PLAN COMMISSION AGENDA
Monday, May 19, 2025 at 6:00 p.m.
Caledonia Village Hall – 5043 Chester Lane
Caledonia, WI 53402

PLAN COMMISSION REPORT

Proposal: Building, Site, & Operation Plan Review

Description: Review of a request to approve a building, site, and operation plan for the construction and utilization of a $\pm 6,713$ square foot industrial building for the property located directly north of 4005 Quick Drive.

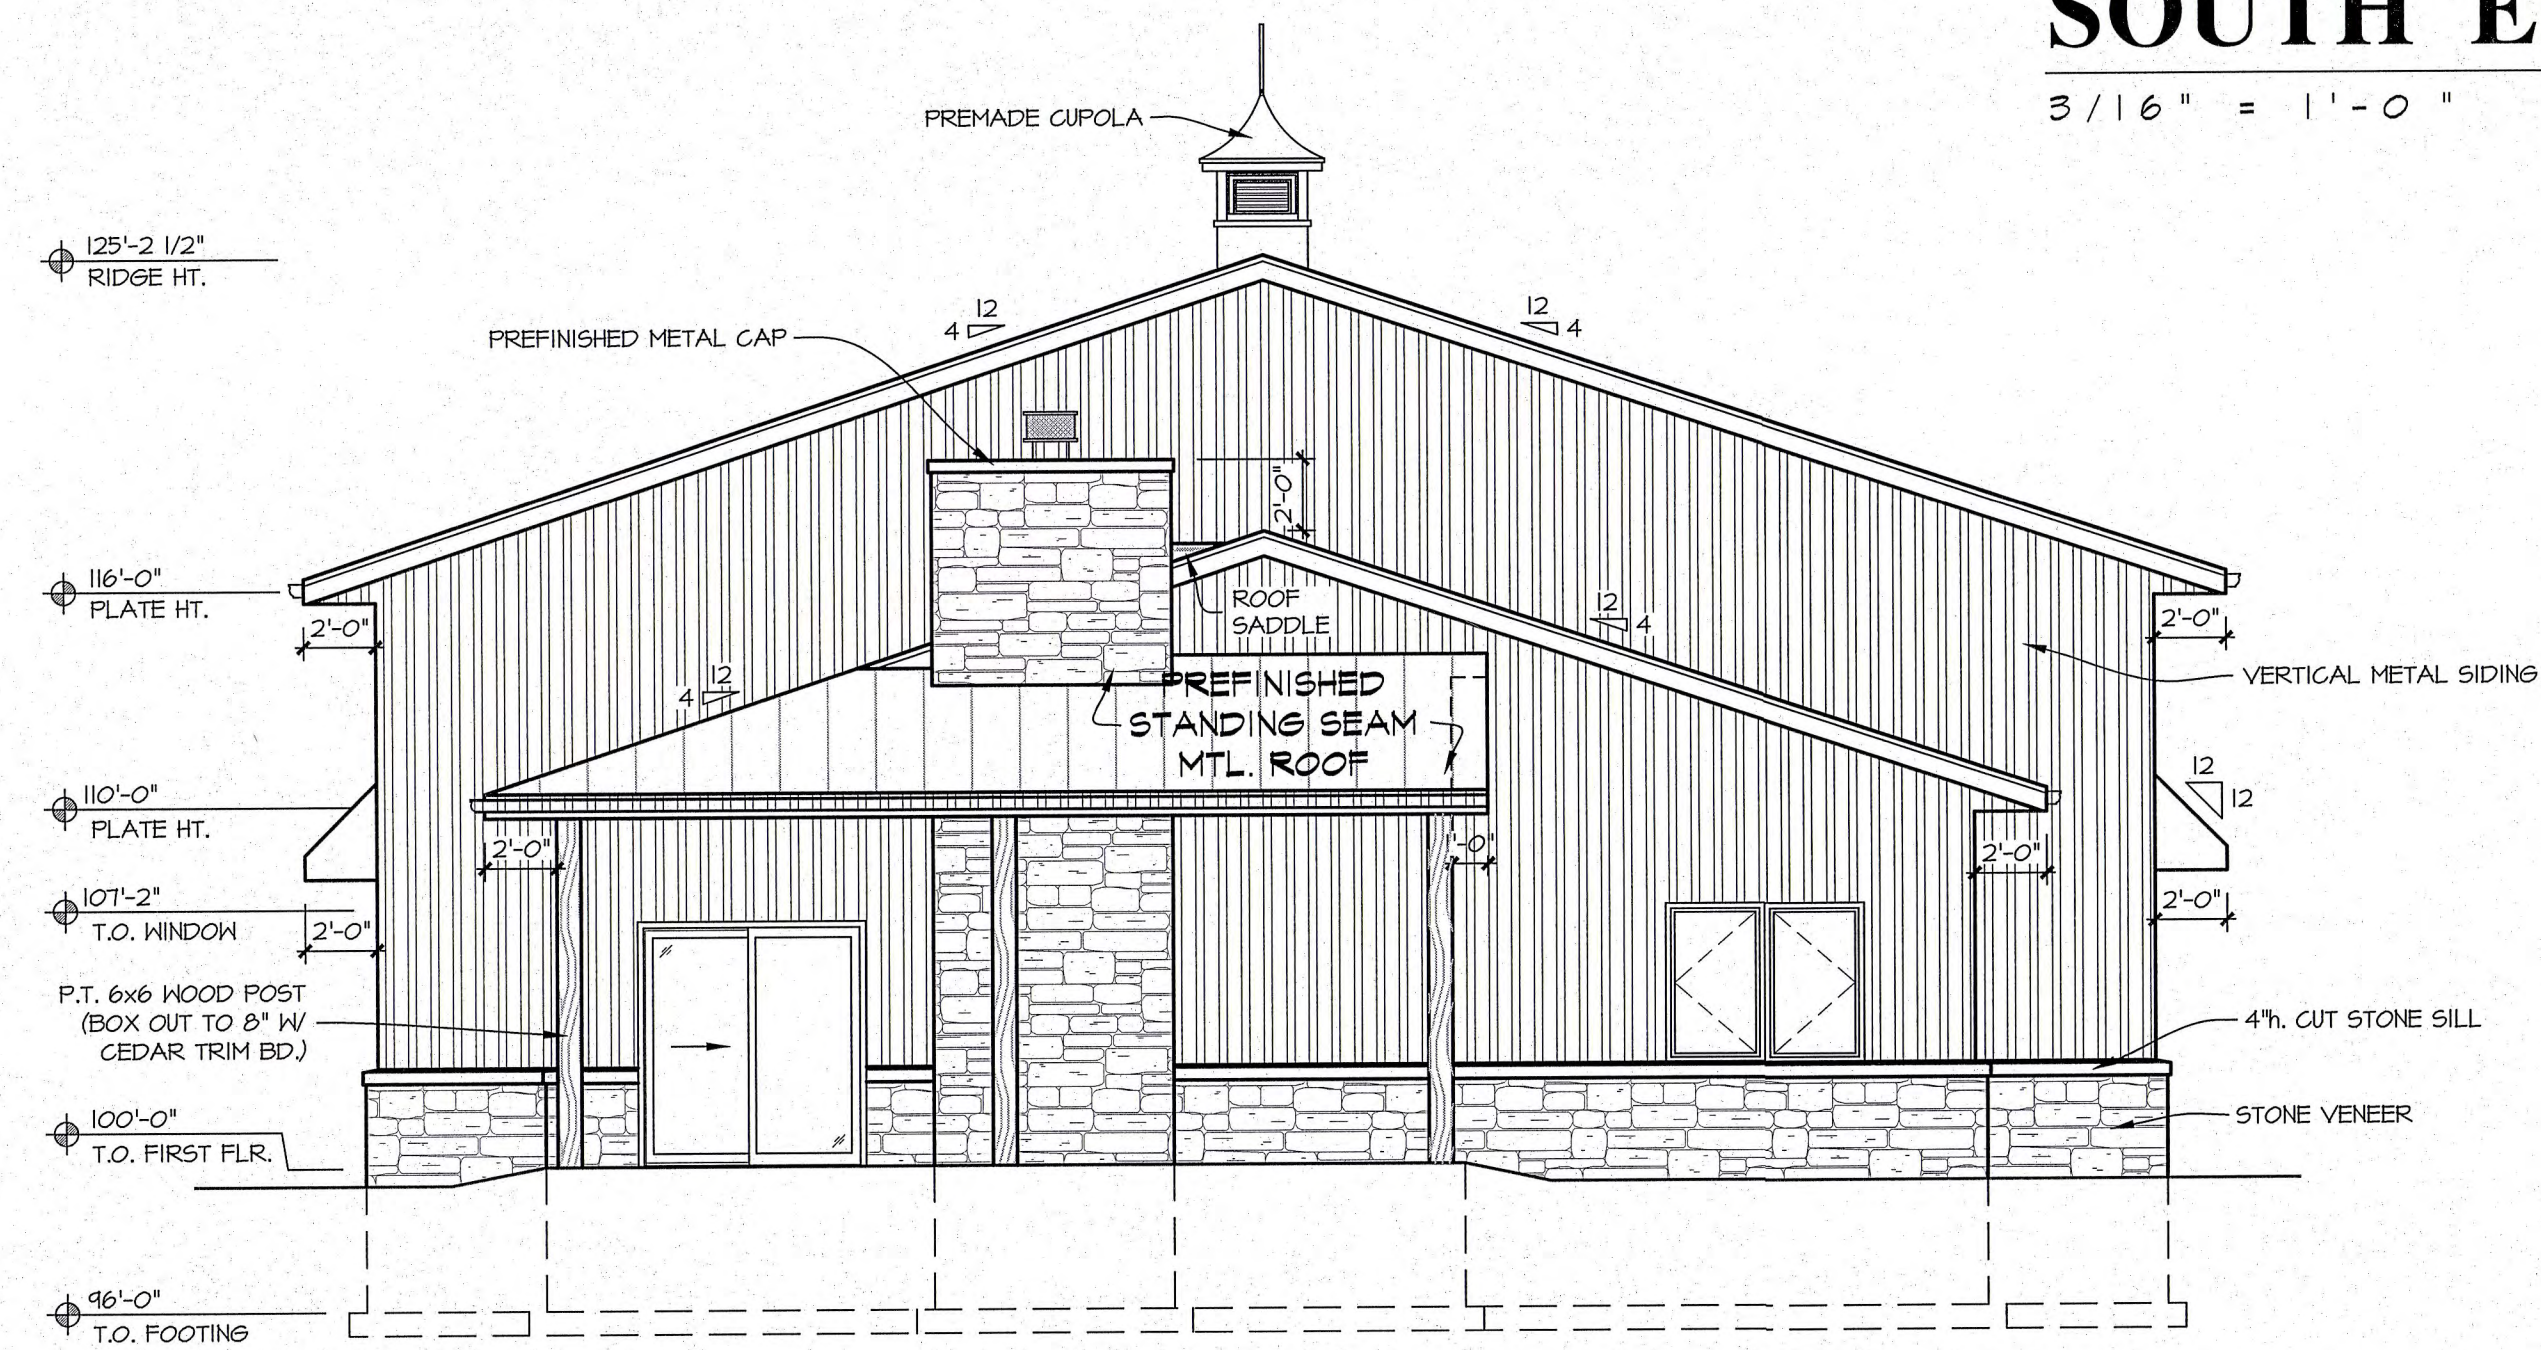
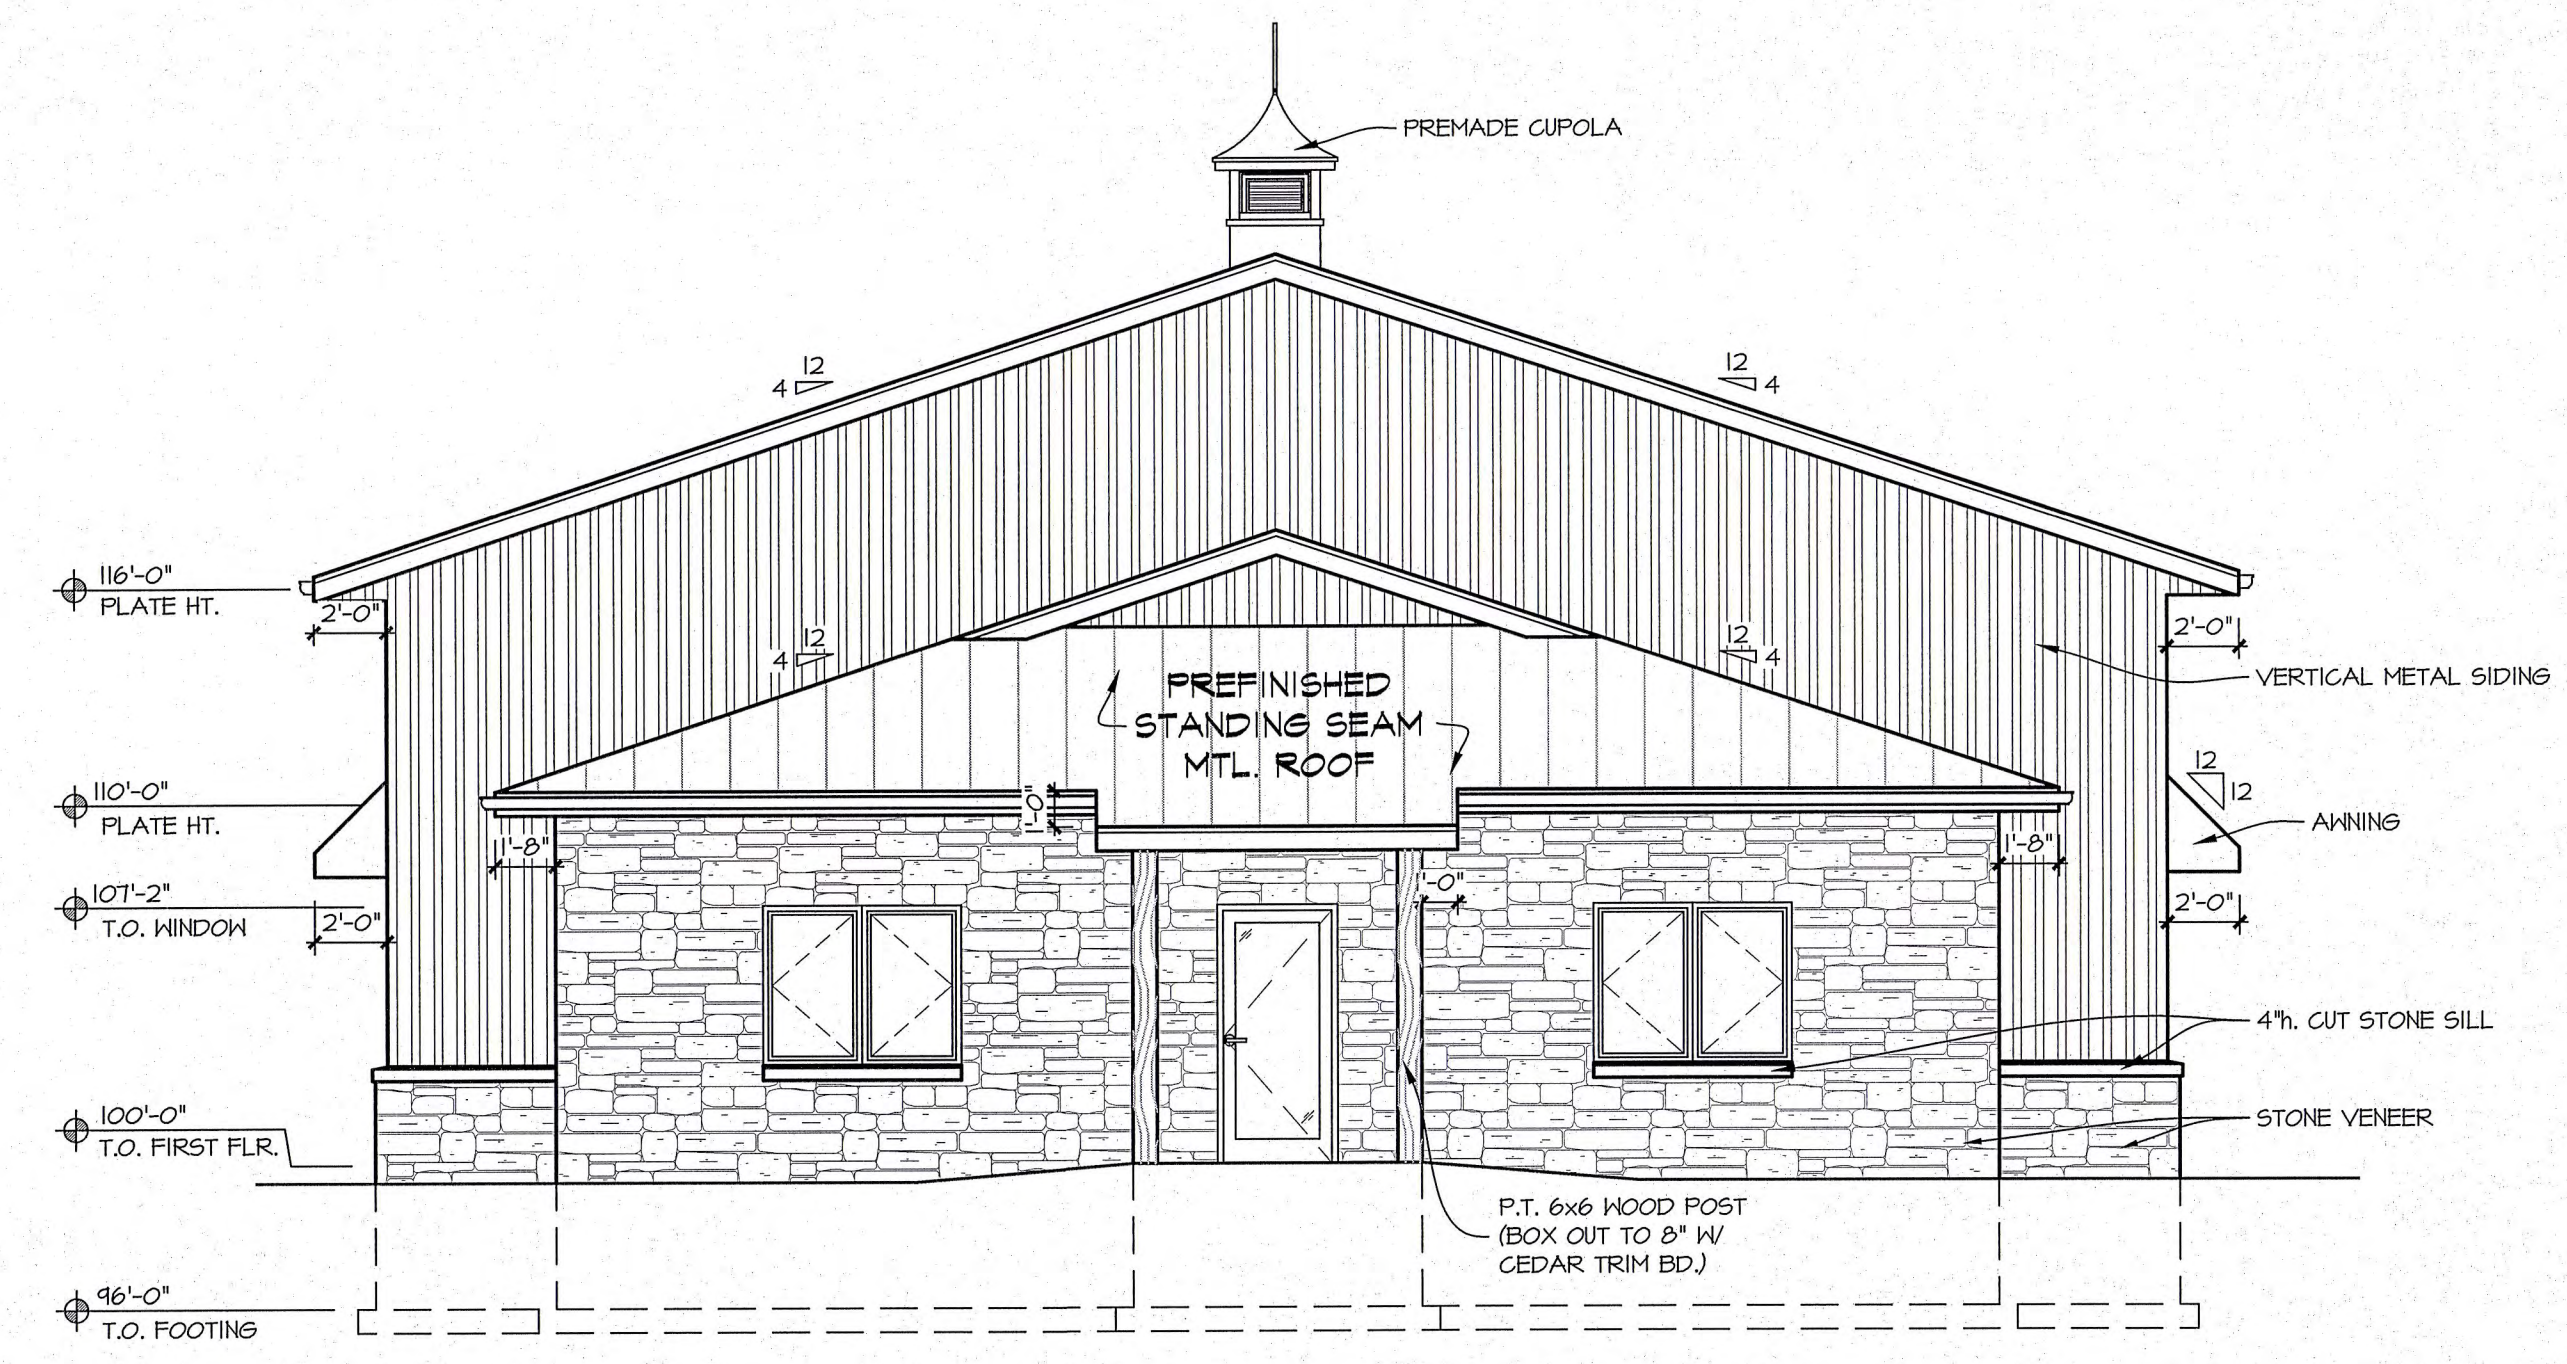
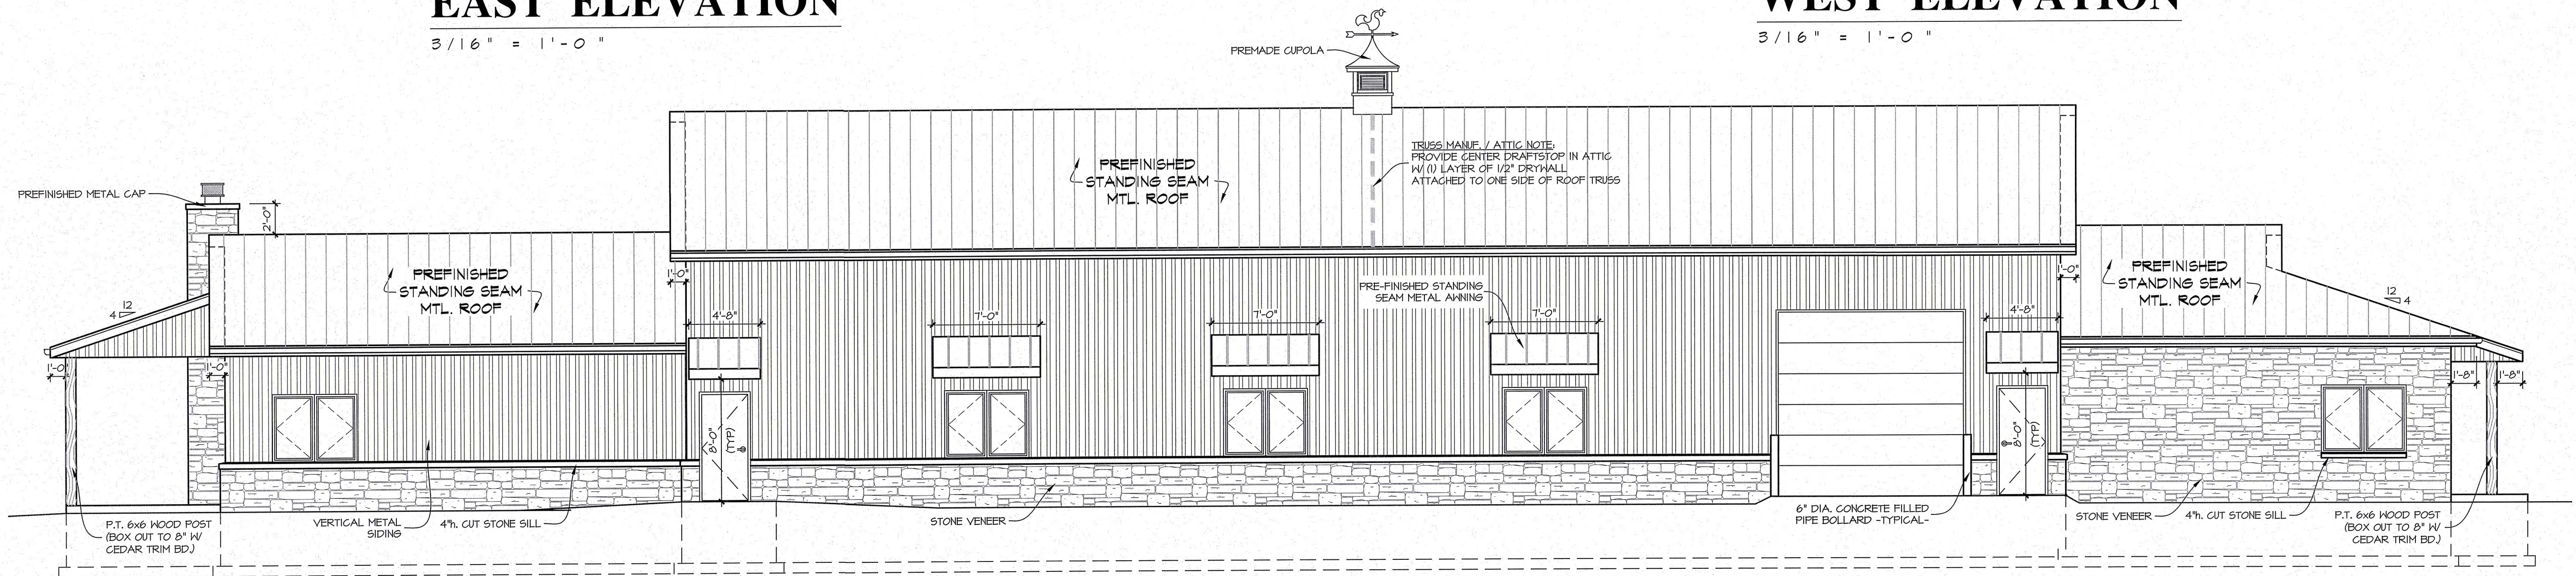
The building will feature metal panel siding with a masonry base on all sides. The west elevation will be consist primarily of masonry. However, the design does not meet zoning requirements that mandate 75% of the visible building perimeter be clad in acceptable exterior materials—metal is not considered a qualifying material under code. A $\frac{3}{4}$ majority vote of the Plan Commission is required to approve the proposed metal exterior.

Staff recommends using matching masonry on the east office portion to mirror the west side. Even with this enhancement, the building still falls short of the 75% masonry requirement.

The north elevation includes one overhead door not facing a public road. Per design standards, loading areas, service entries, and mechanical equipment must be screened or attractively designed to minimize visual impact. Screening options include densely planted trees or shrubs, opaque fencing, and/or garden walls at least 7 feet tall (plant material must reach 7 feet within 2 years). Staff recommends additional screening be installed on the northwestern portion of the site to minimize visual impact of the overhead door.
